PERCOLATION TESTING

HOWARD COUNTY HEALTH DEPARTMENT BUREAU OF ENVIRONMENTAL HEALTH PO. BOX 476 ELLICOTT CITY, MARYLAND 21043 TELEPHONE: 461-9933

RE: Percolation Test Results

Application Numbers: A46867 - A46870 Proposed Use: Subdivision - Minor

A 46870

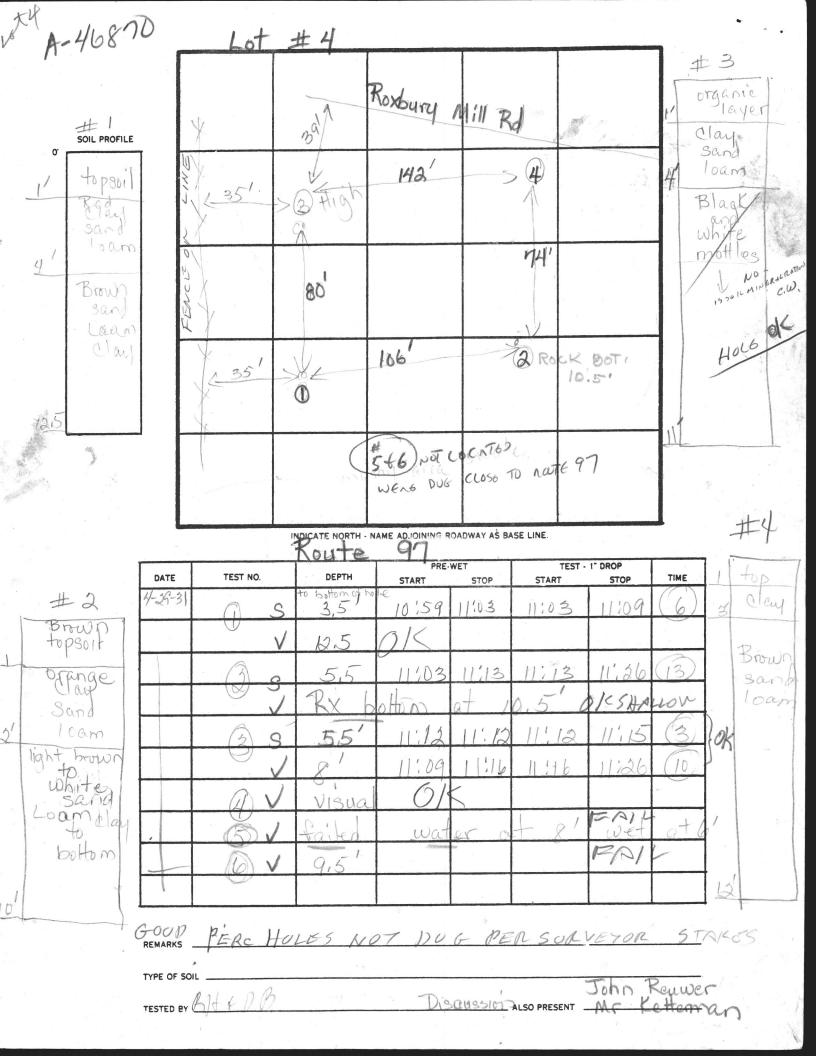
3-5-9! Preview ok. LID,000 sq ft. SDA. Must maintain 25 ft. from swale. Possible wet soils due to landscape position. Align SDA toward Lot-3

A 46869

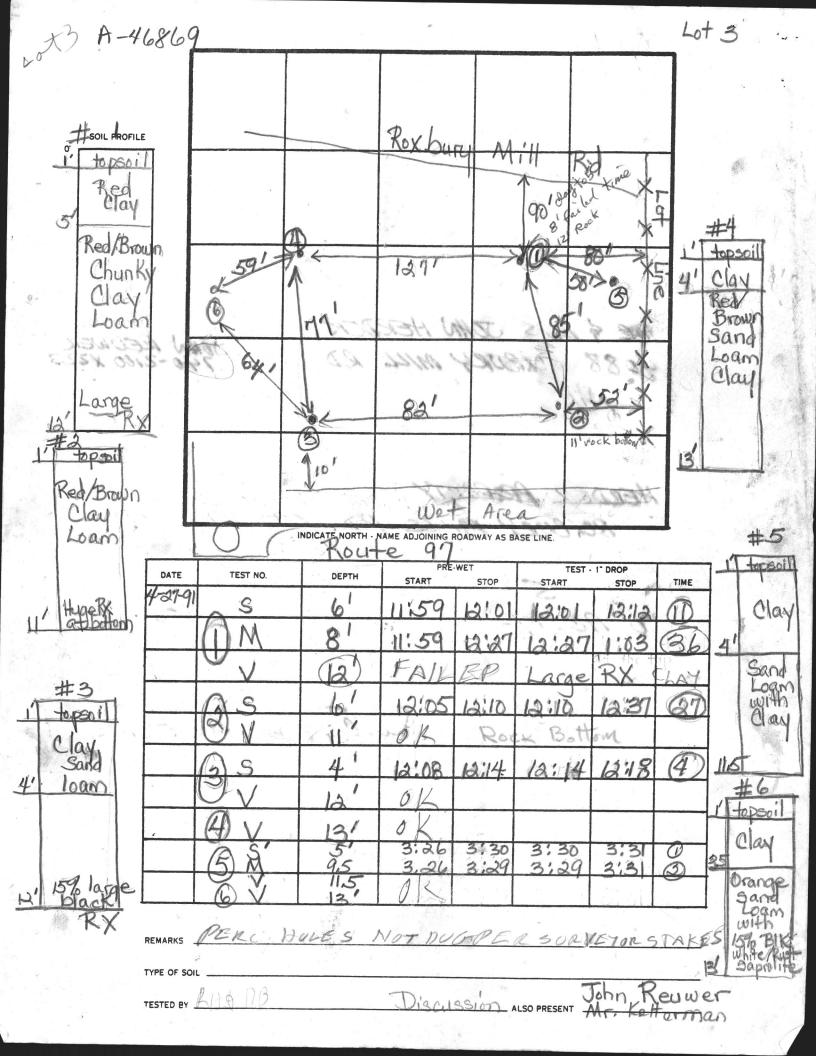
HOWARD COUNTY HEALTH DEPARTMENT BUREAU OF ENVIRONMENTAL HEALTH P.O. BOX 476 ELLICOTT CITY, MARYLAND 21043 TELEPHONE: 461-9933 3-5-91 Preview ok. Swale may be wet JEN
